Access Compliance Report

Public Rights-of-Way

(Curb Ramps)

Intersection ID: 51073	Main Street: RISBURG_LN	Cross Street: KEMPSFORD_DR	Location:	N
ADA ID: 13E7A22AFFB9	Ramp Type: PerpDiag	Initial Pass/Fail: Fail	Overall Compliance: No	Severity Score: 22.5
Codes/Mitigation Info/Possible Solution		Field Measurements/Component Compliance

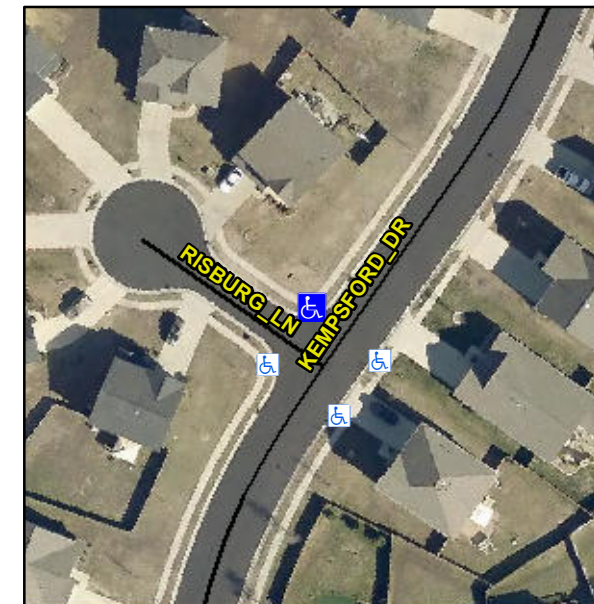
Not Found, R304.5.1, R304.2.2, R304.5.3

Compliance	Description	Data	Compliance	Description	Data
N/A	Ramp Length (in)	46.0	No	Ramp Slope (%)	10.2
No	Ramp Width (in)	36.0	No	Ramp XSlope (%)	3.3
N/A	Flare Type LT	N/A	N/A	Flare Type RT	N/A
N/A	Flare Slope LT (%)	N/A	N/A	Flare Slope RT (%)	N/A
N/A	Flare Traversable LT?	N/A	N/A	Flare Traversable RT?	N/A
N/A	Landing Length (in)	N/A	N/A	DWS Provided?	N/A
N/A	Landing Width (in)	N/A	N/A	DWS Contrast?	N/A
N/A	Landing Slope (%)	N/A	N/A	DWS Length (in)	N/A
N/A	Landing X Slope (%)	N/A	N/A	DWS Full Width?	N/A
N/A	Landing Curb? (Y/N)	N/A	N/A	DWS Offset (in)	N/A
N/A	Shared Landing?	N/A			
N/A	Gutter Ponding?	N/A	N/A	Gutter Slope (%)	N/A
N/A	Gutter Lip Ht (in)	N/A	N/A	Gutter X Slope (%)	N/A
N/A	Painted X Walk1?	No	N/A	Painted X Walk2?	No
	X Walk 1 Direction	To SW		X Walk 2 Direction	To SE
N/A	X Walk 1 Width (in)	N/A	N/A	X Walk 2 Width (in)	N/A
	X Walk 1 Slope (%)	3.4		X Walk 2 Slope (%)	1.3
	X Walk 1 X Slope (%)	1.0		X Walk 2 X Slope (%)	1.0

Remove & Replace Curb Ramp With Two New Directional Ramps or Equivalent.
